**DEVELOPMENT REVIEW BOARD MEETING  
FEBRUARY 11, 2019  
6:30 PM**

**A. Resolution No. 360. Frog Pond Meadows: Li Alligood, AICP, Otak – Representative for West Hills Land Development – Applicant.** The applicant is requesting approval of an Annexation and Zone Map Amendment from Rural Residential Farm Forest 5-Acre (RRFF-5) to Residential Neighborhood (RN) and Public Facility (PF) for approximately 23.9 acres of property located on the west side of Stafford Road just north of Boeckman Road, and adopting findings and conditions approving a Stage I Preliminary Plan, Stage II Final Plan, Site Design Review of parks and open space, Tentative Subdivision Plat, Tentative Partition Plat (Church property), Tentative Partition Plat (School property), Type C Tree Plan, Waiver to Minimum Lot Size, Waiver to Minimum Front Setback, and Abbreviated SRIR Review for a 74-lot single-family subdivision. The subject site is located on Tax Lots 1800, 1902, 1903, 2000 and 2200 and portion of Stafford Road right-of-way of Section 12D, Township 3 South, Range 1 West, Willamette Meridian, Clackamas County, Oregon. Staff: Kimberly Rybold

Exhibit A1  
Staff Report  
Frog Pond Meadows 74-Lot Single-Family

**P2.00**

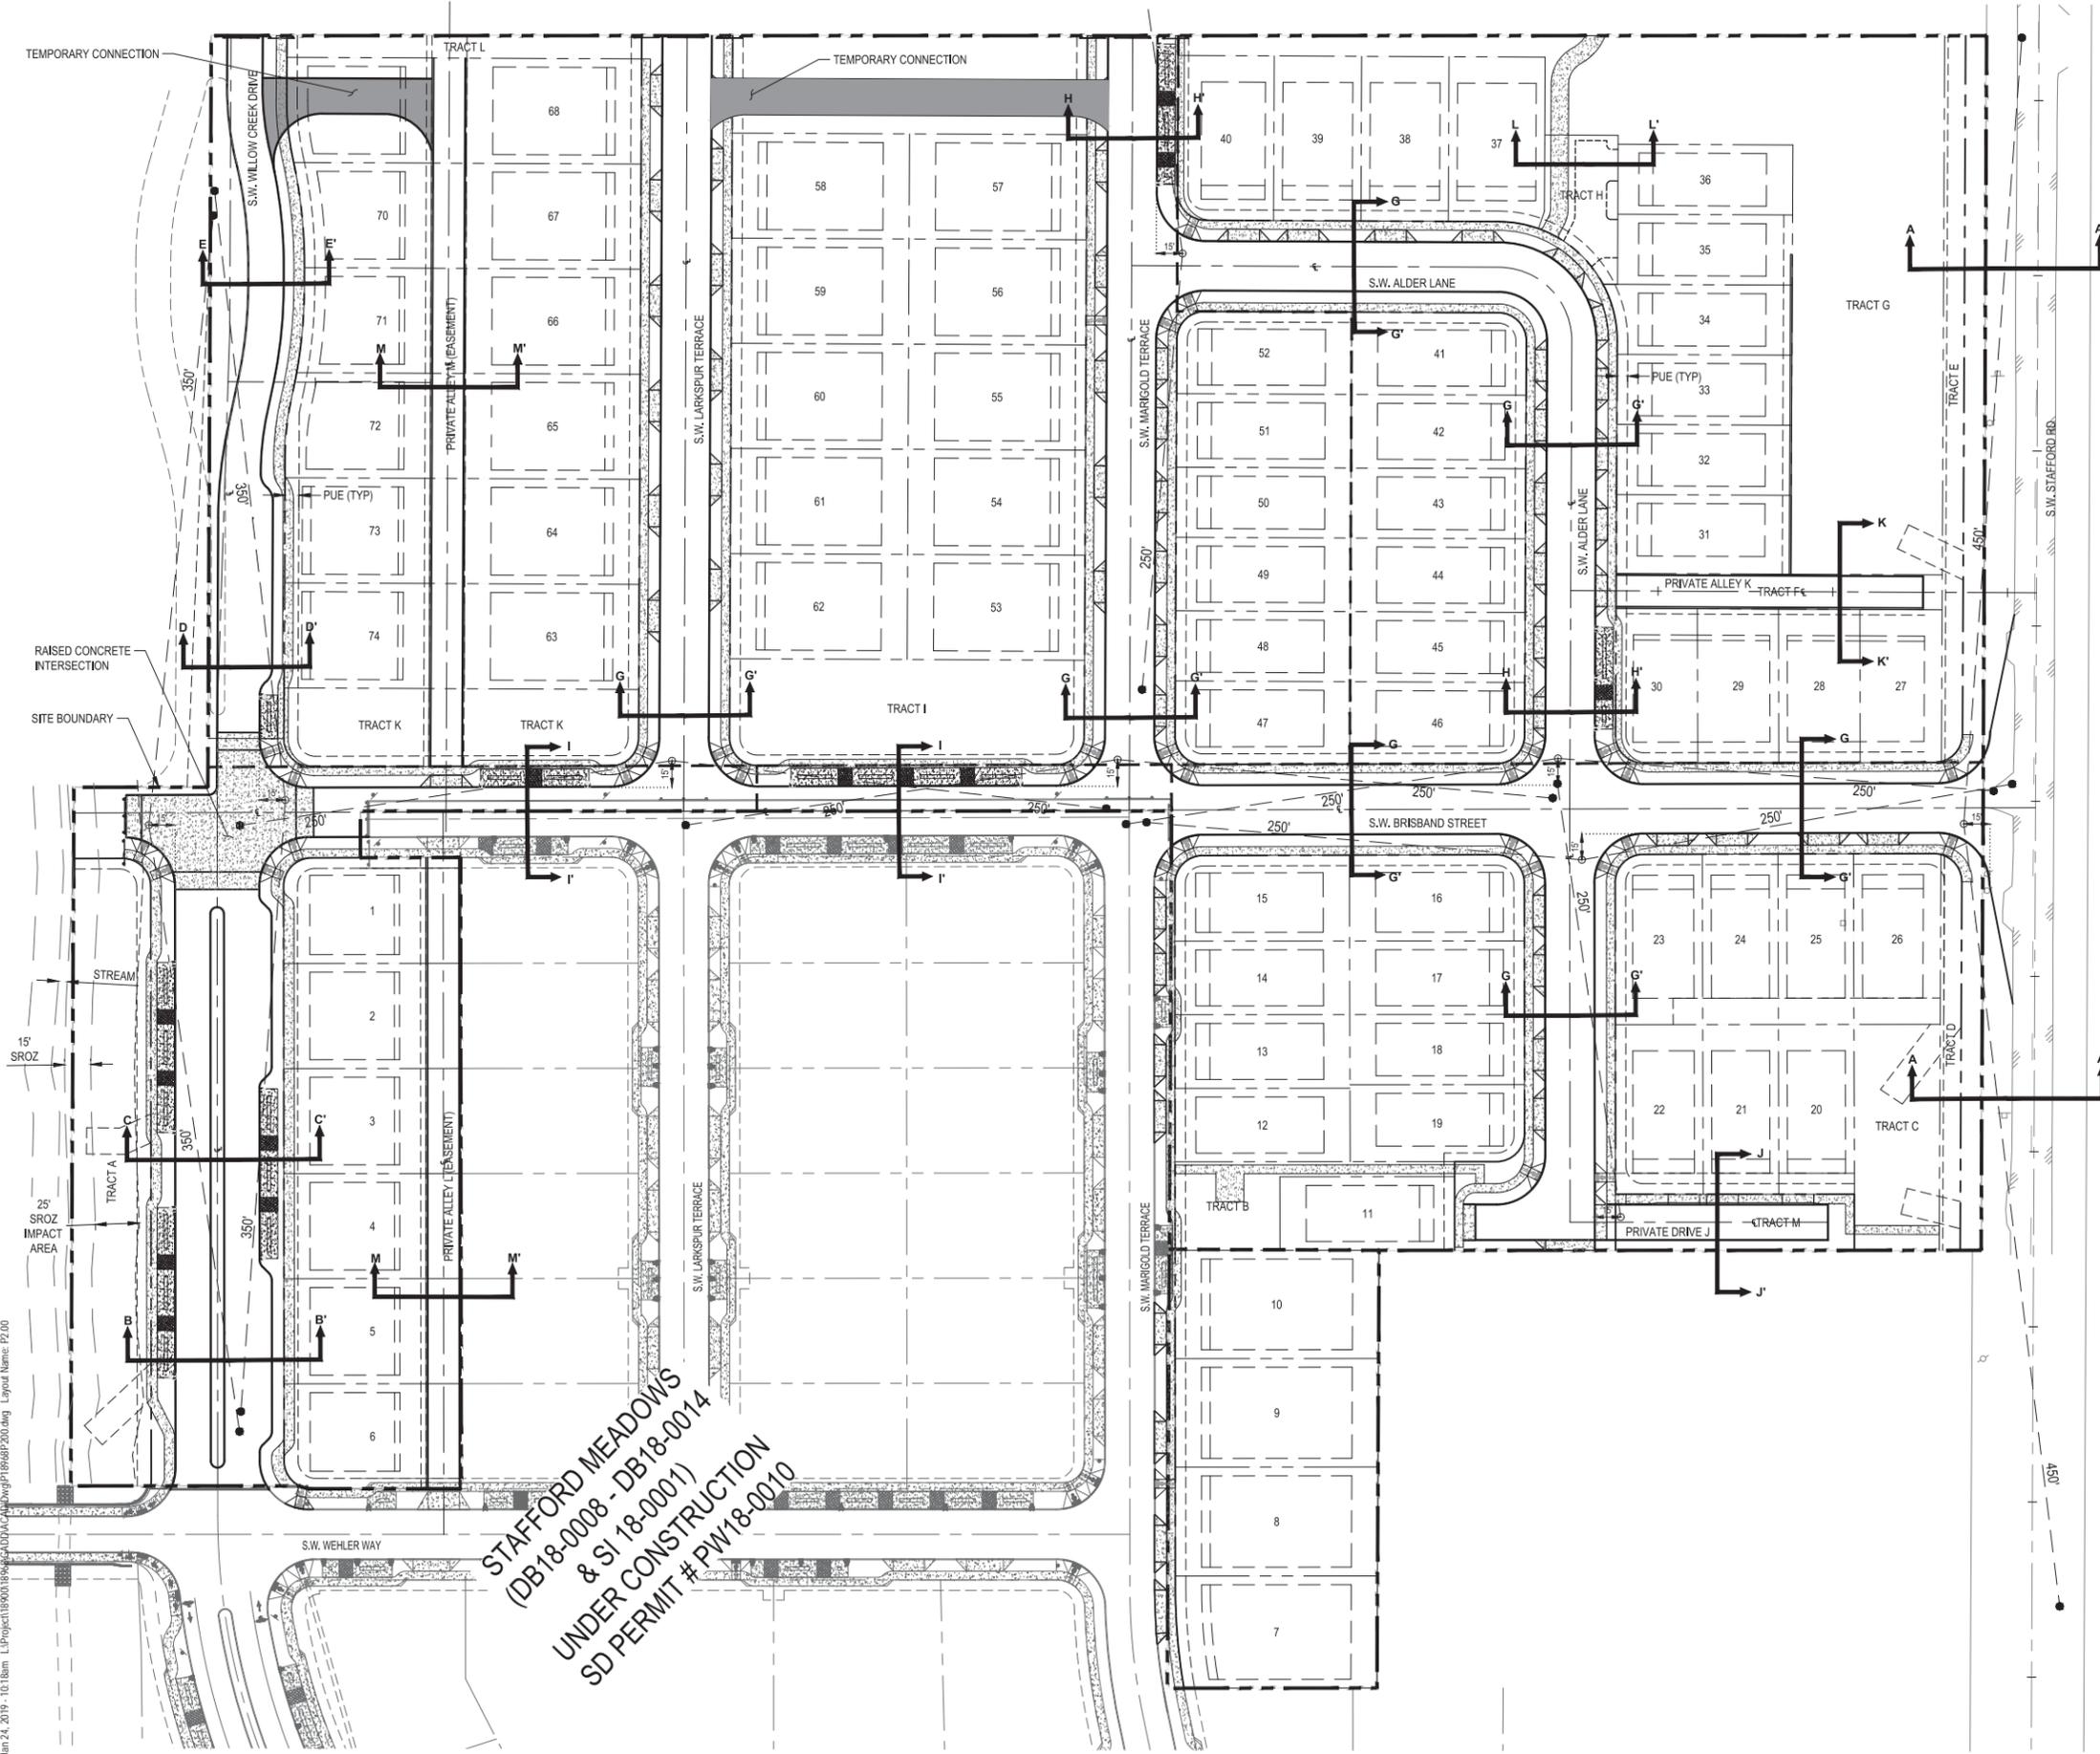
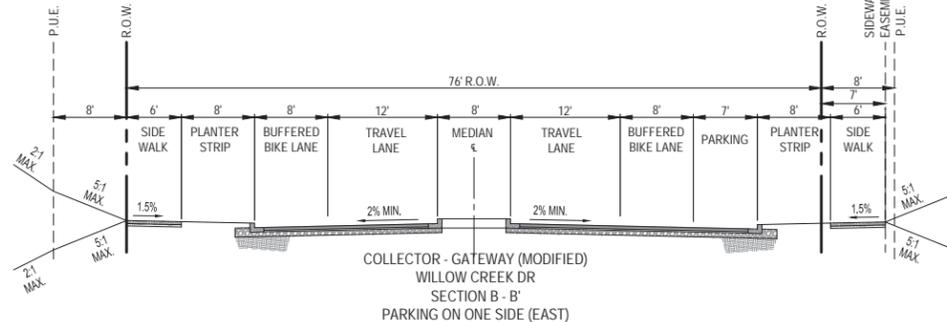
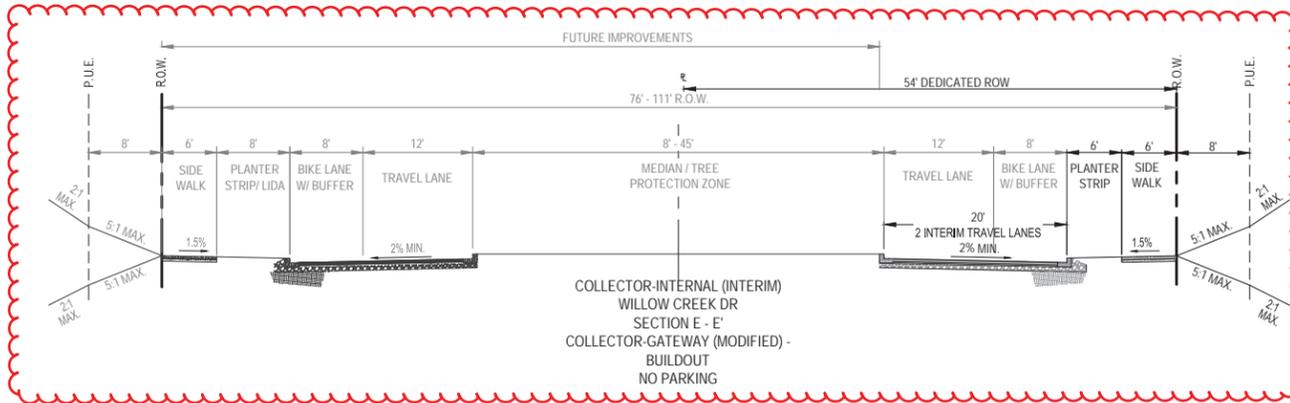
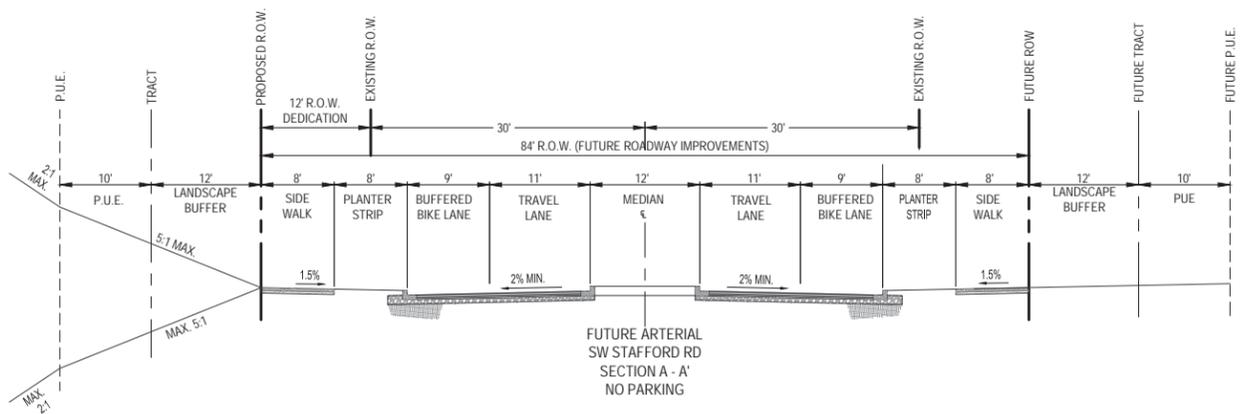
I have reviewed and approve the Applicant's requested changes to the cross-section of the proposed Willow Creek Drive north of Brisband Street, as shown in the attached sheets P2.00, P2.10 and P4.00, by adding up to a 45-foot wide (ultimate build-out) landscape median to allow retention of the existing 34" white oak tree, and a temporary, partial construction of the eastern section of the street. The developer of tax lot 31W12D 01500 will be required to build the west portion of the roadway, and remove approximately 4 feet of the temporary roadway to construct a landscape median.

P2.10

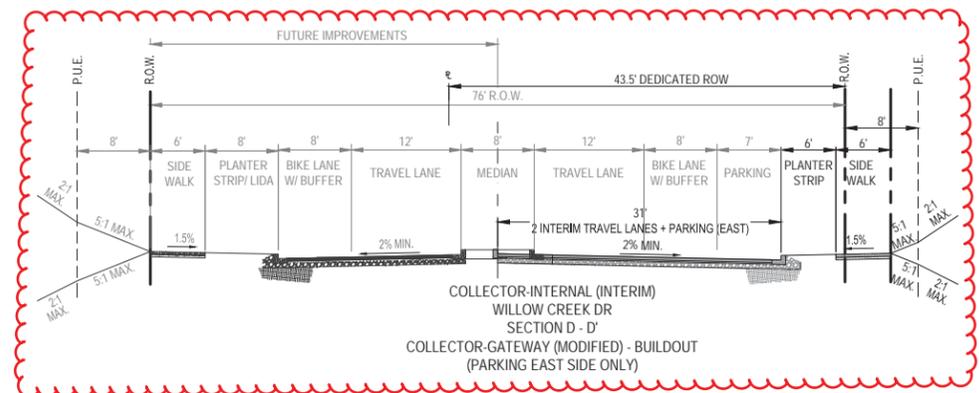
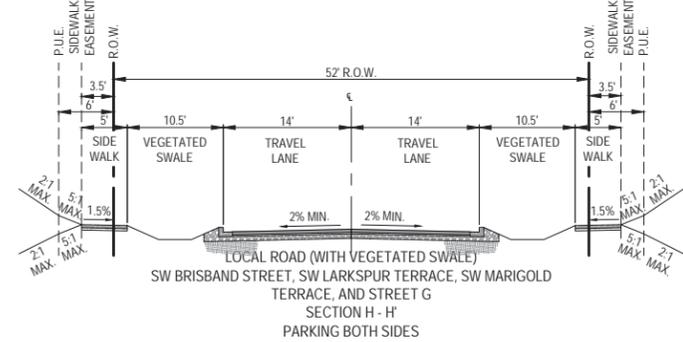
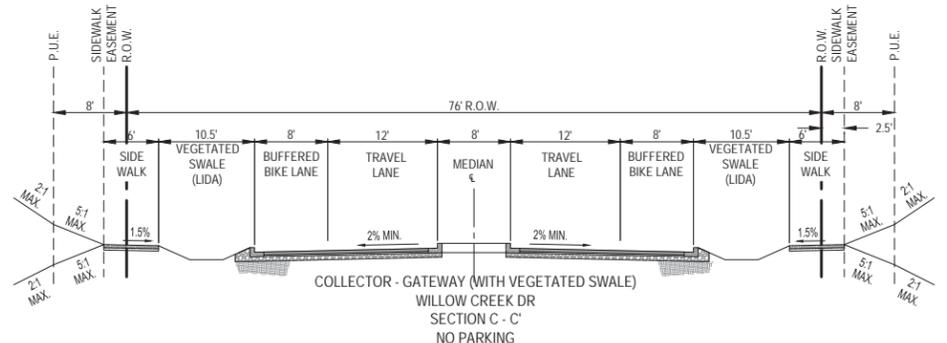
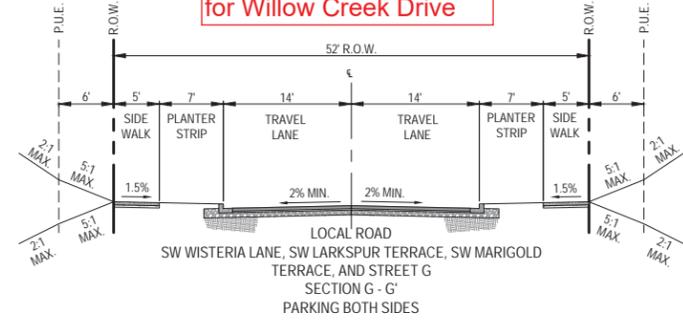
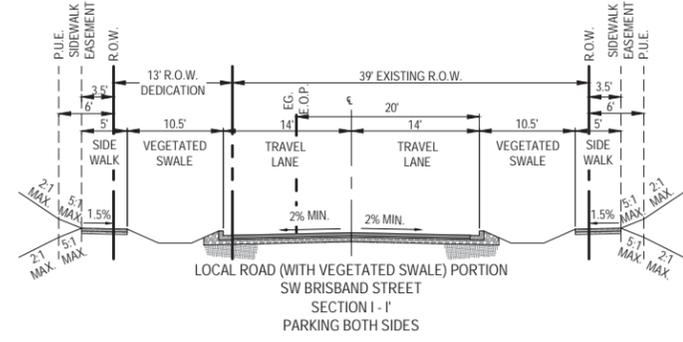
Proposed revised section for Willow Creek Drive

Proposed revised section for Willow Creek Drive
